CLIENT	Fortis Development Group
JOB	1728 Fortis South Steyne 34-35 South Steyne Manly NSW

PROJECT NO.	ISSUE	REV.
1728	S4.55	DA-L
DRAWING NO.		
A-DA-110-000

CHANGES RELEVANT TO THIS MODIFICATION APPLICATION

3 Section E 1:100

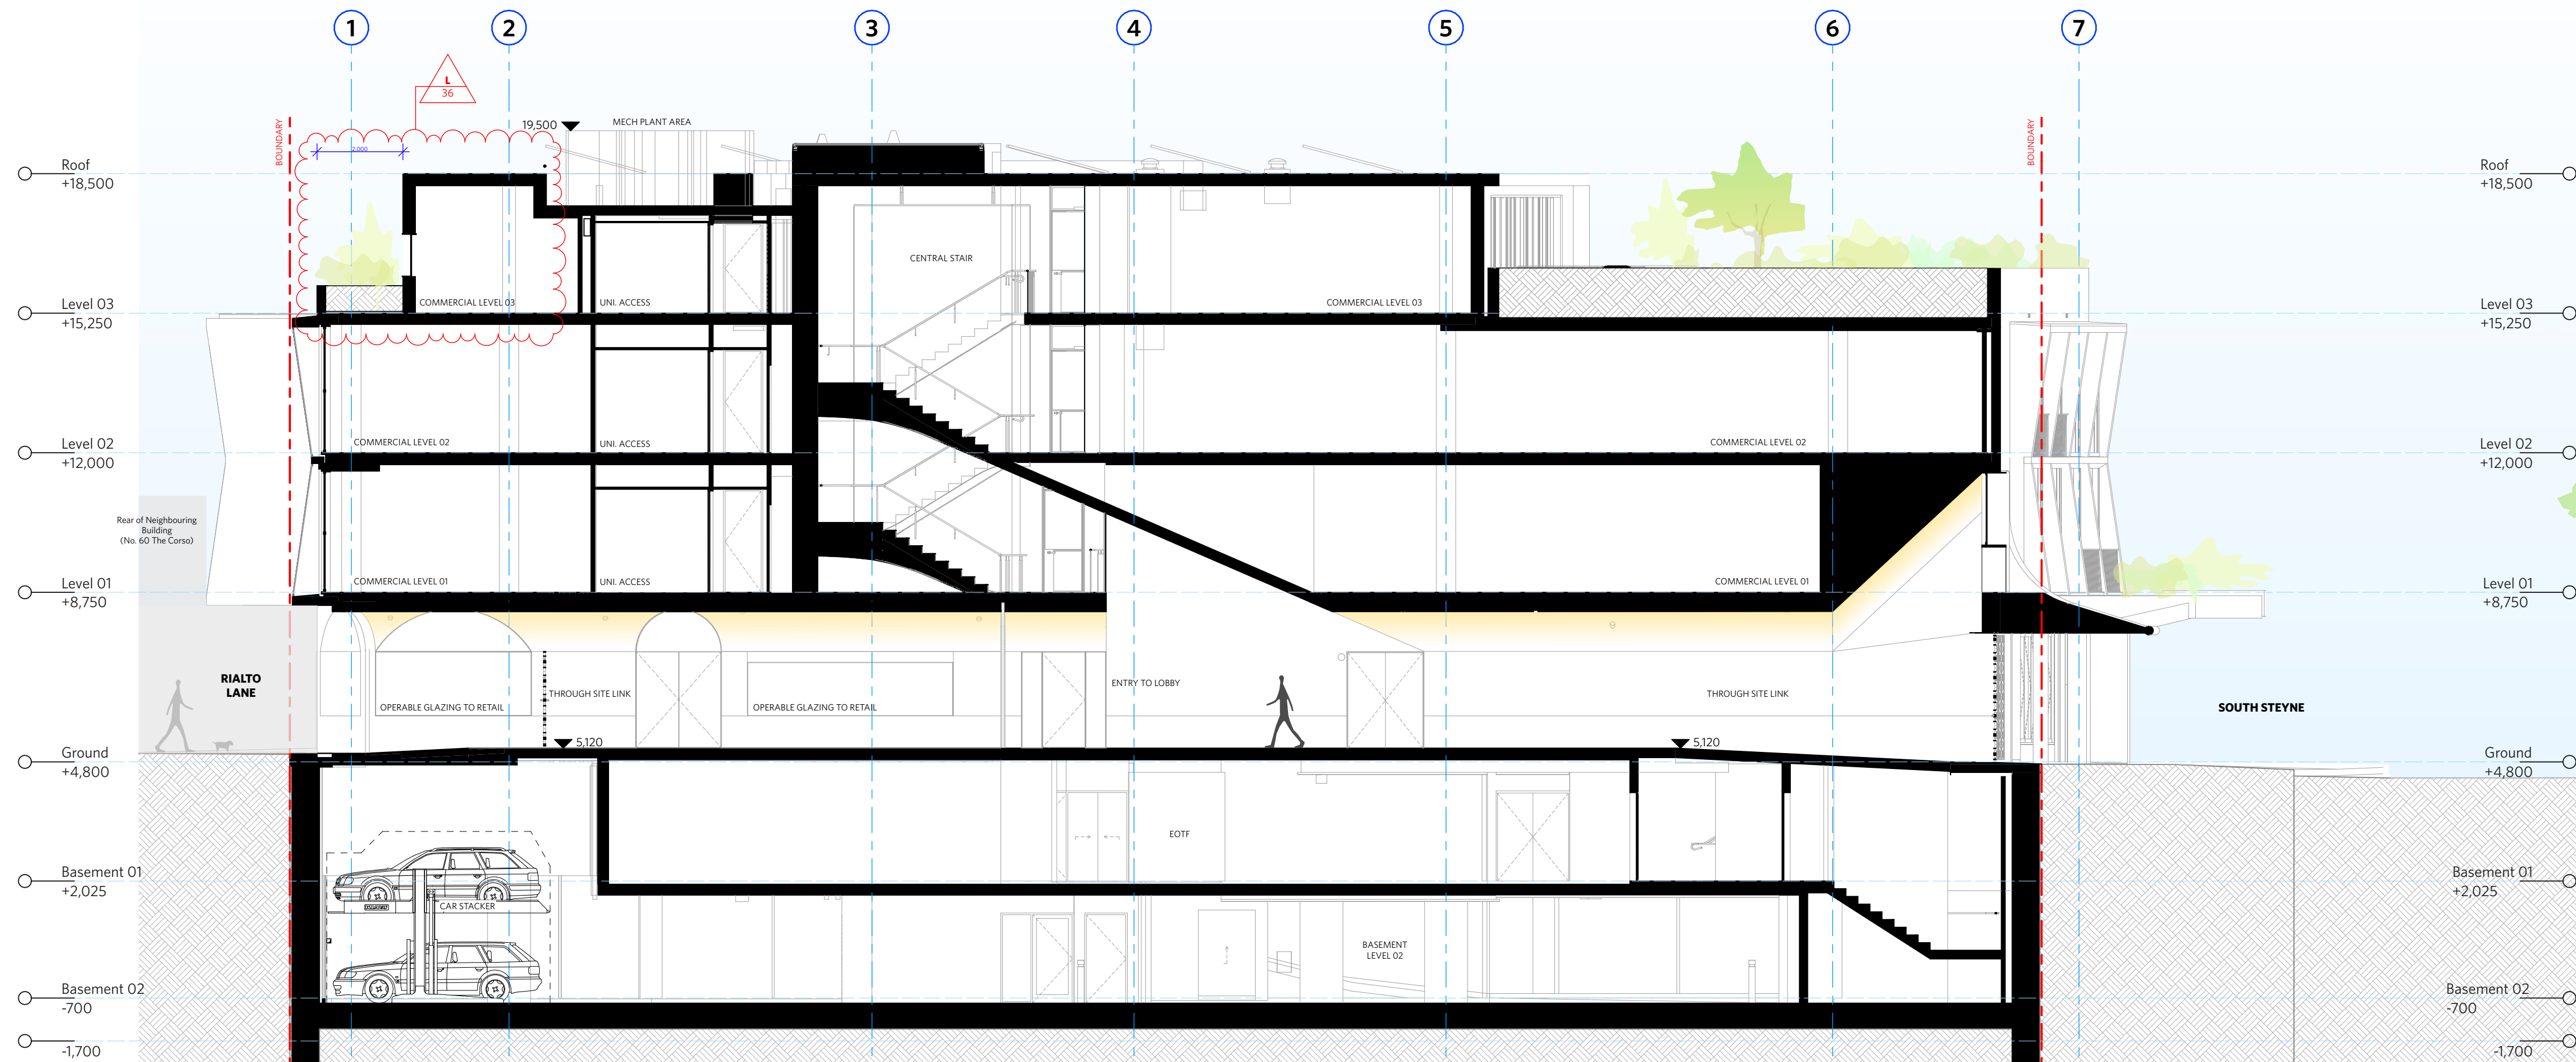
REV	CHANGE	DESCRIPTION
DA-L	36	Change of Layout to Level 03 Floor

TITLE	GFA & NLA Diagrams GFA Diagrams Sheet 1
-------	--

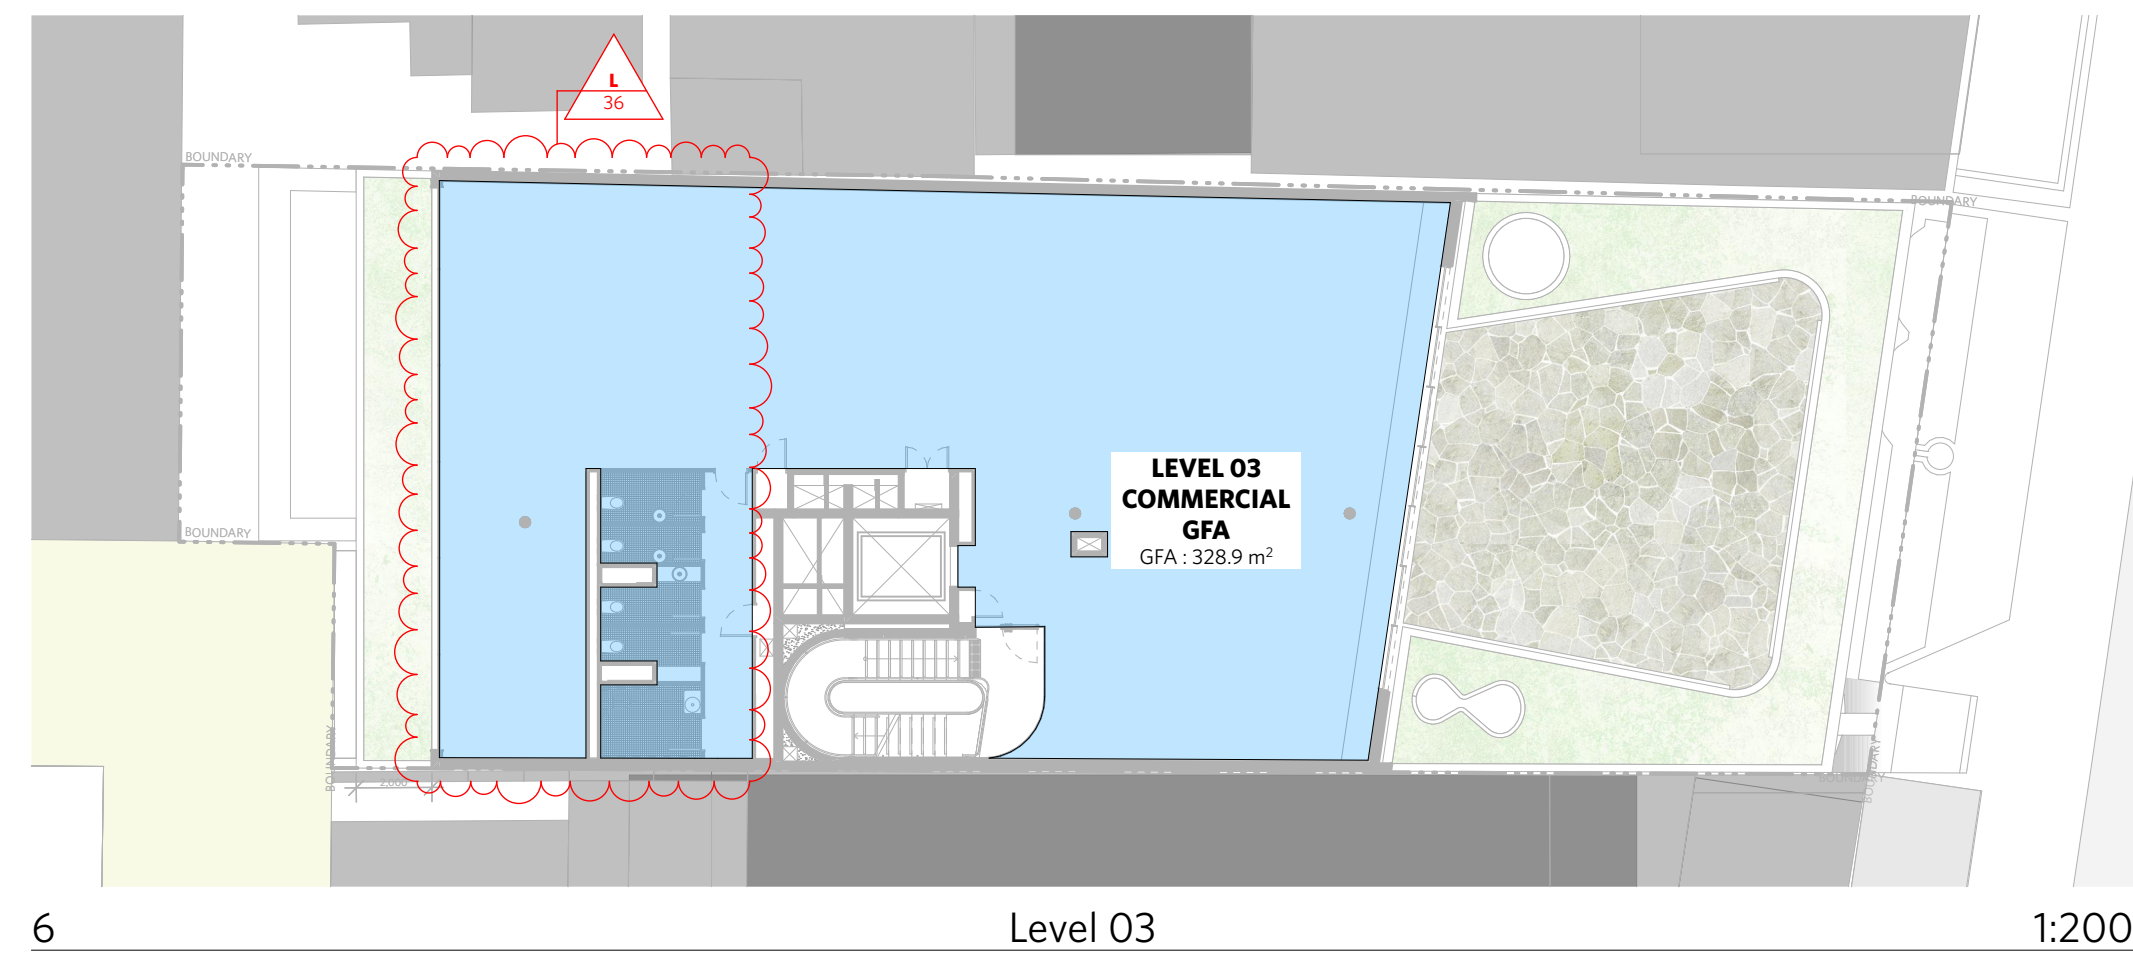
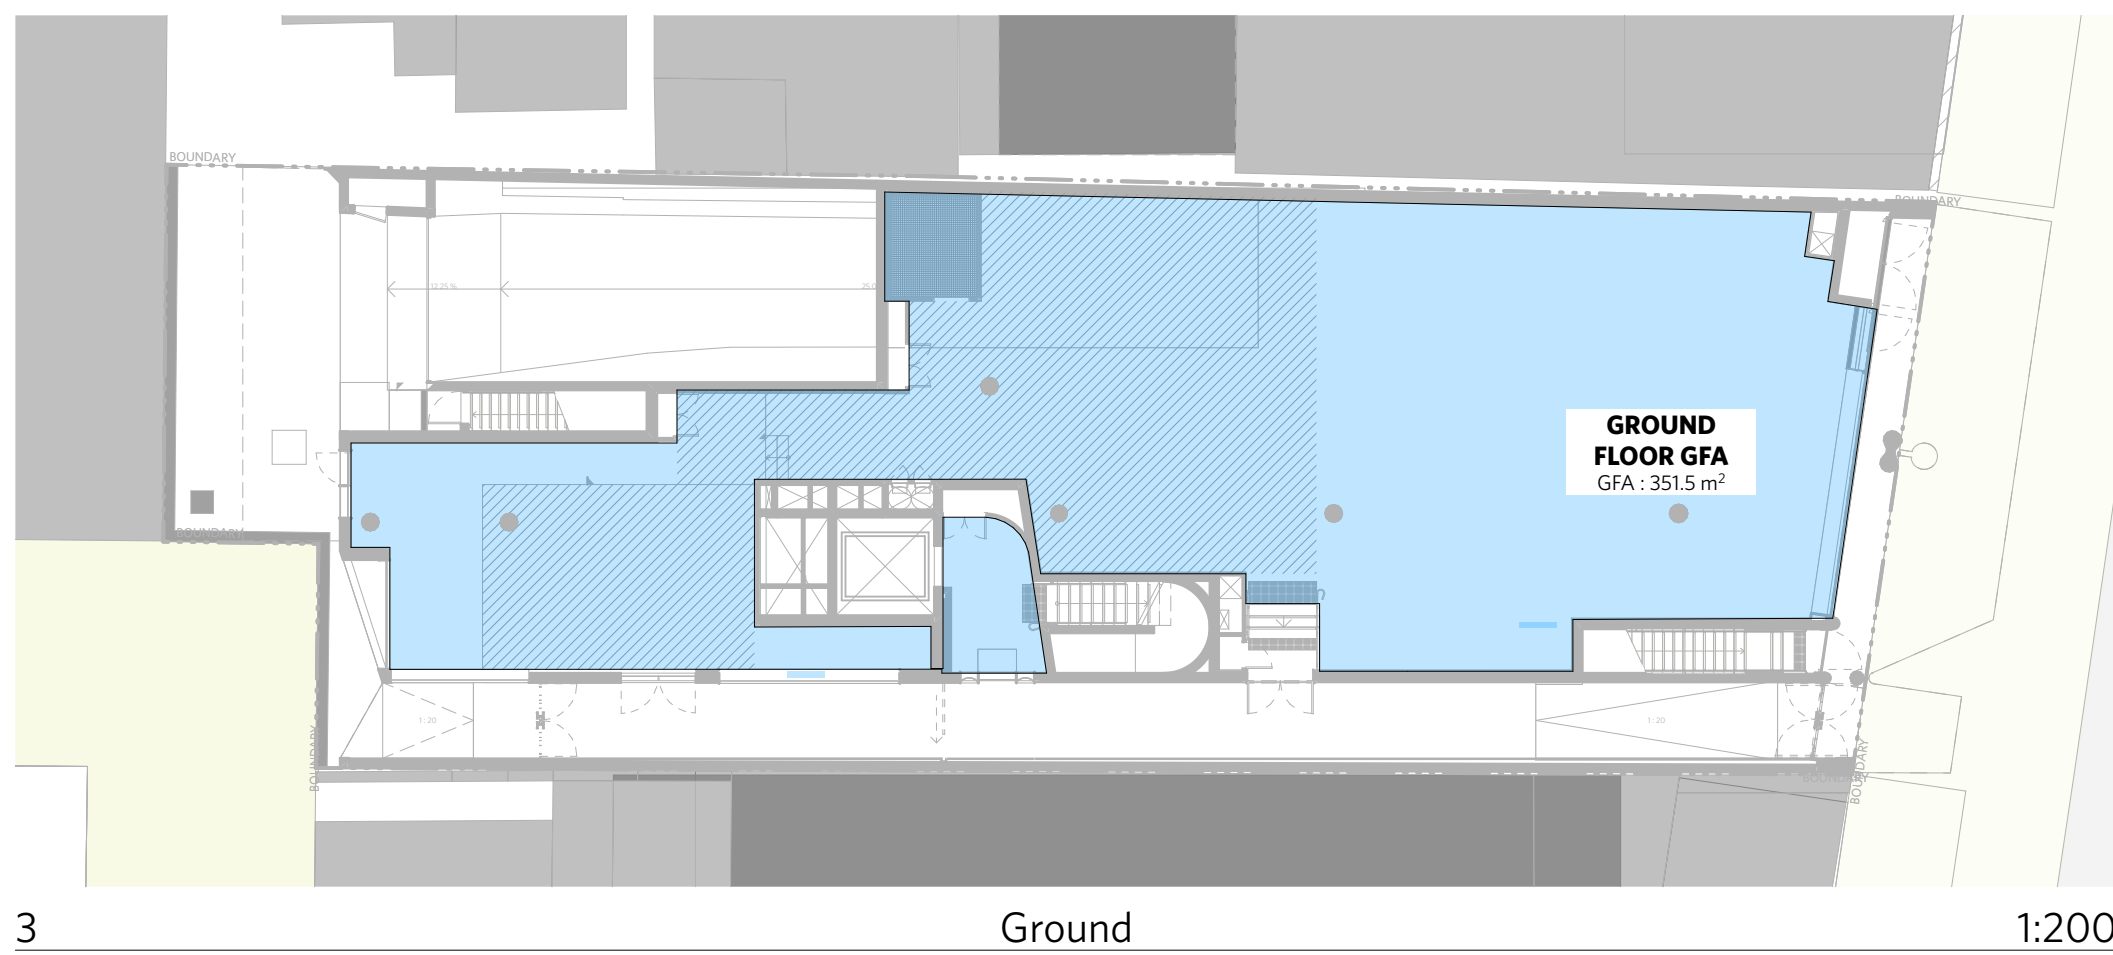
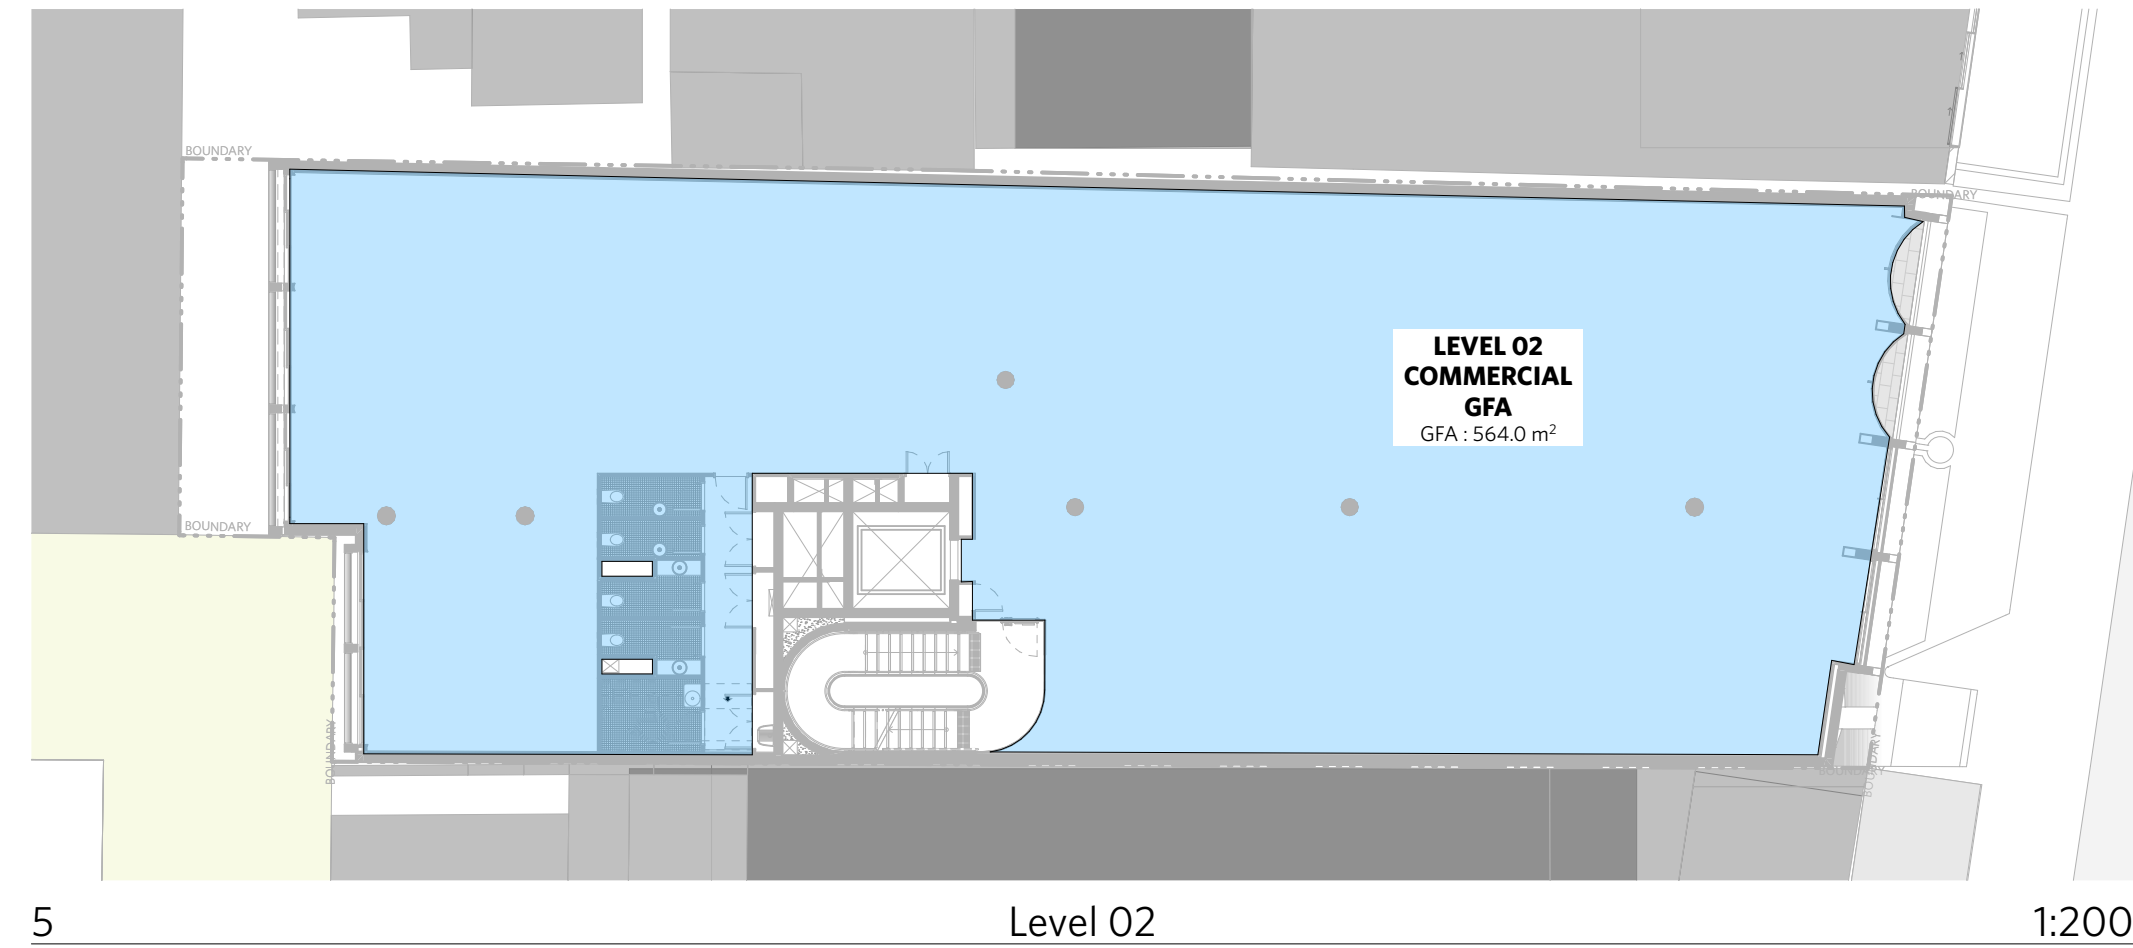
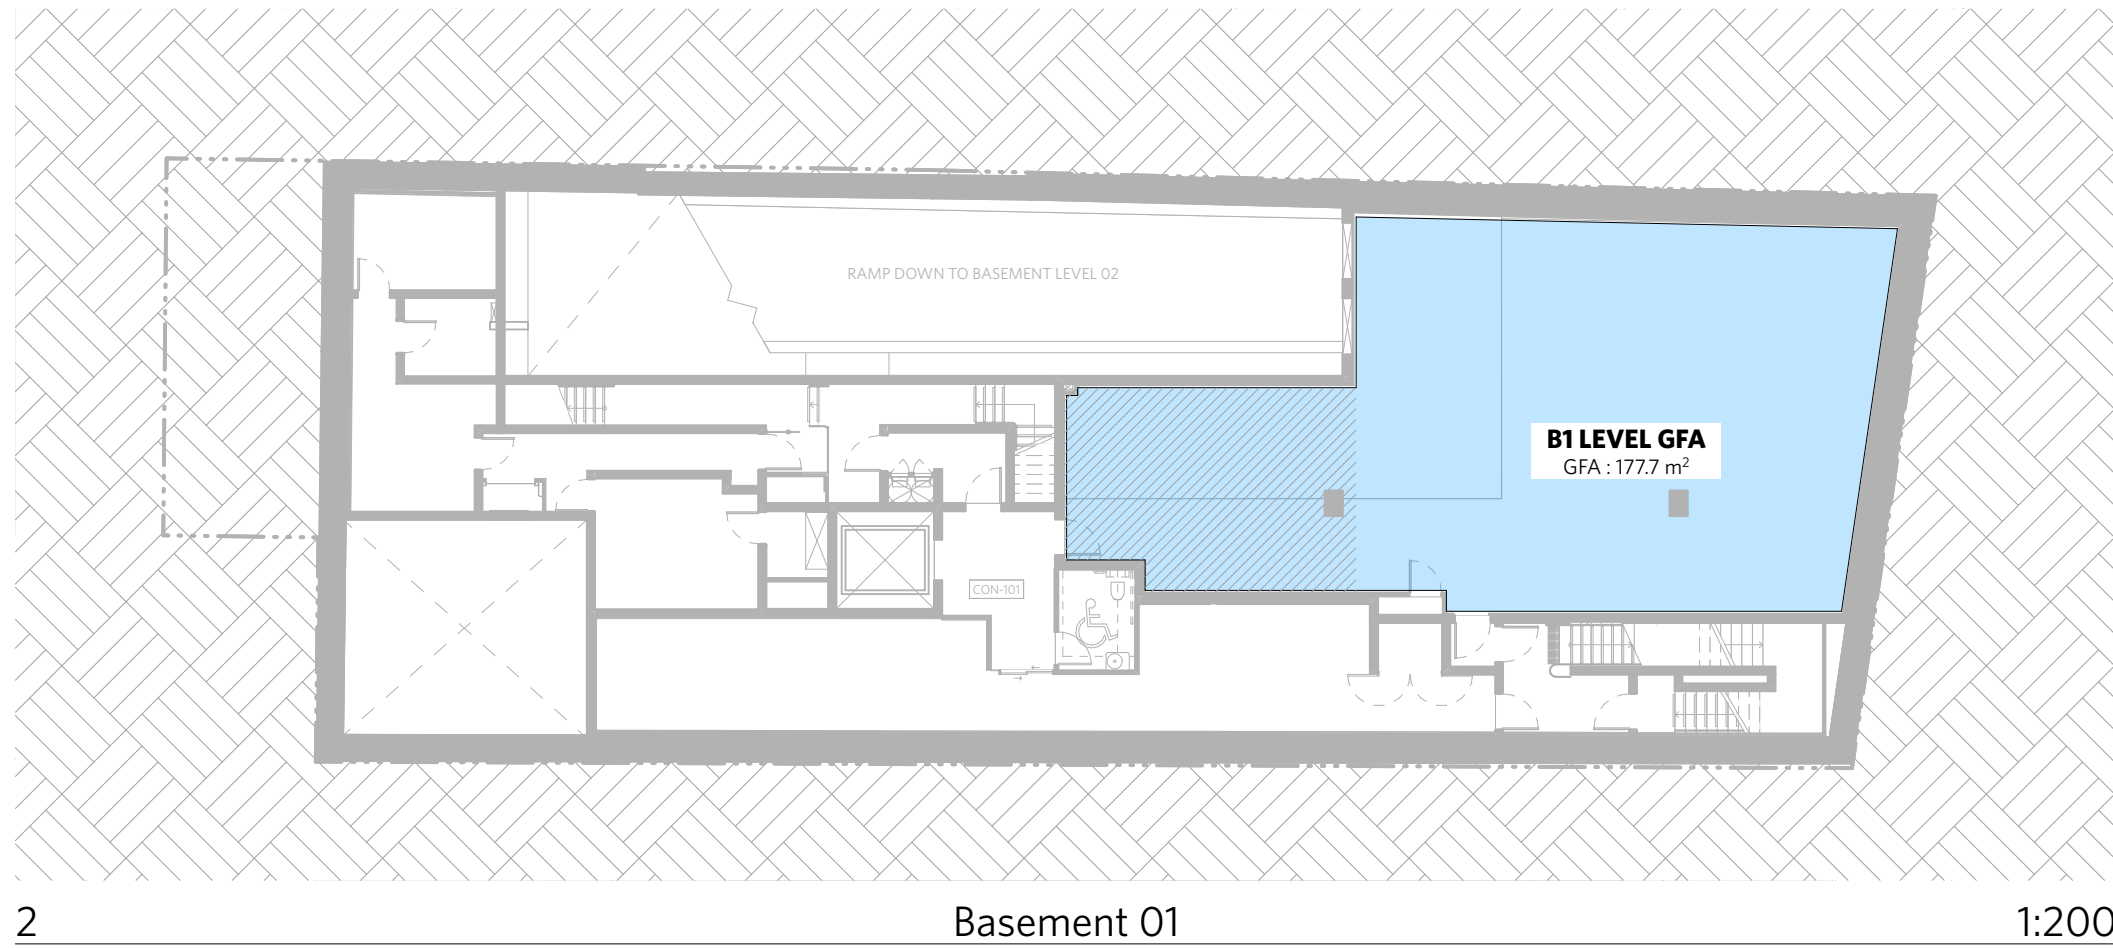
CHANGE SUMMARY		
REV	CHANGE	DESCRIPTION
DA-L	36	Change of Layout to Level 03 Floor
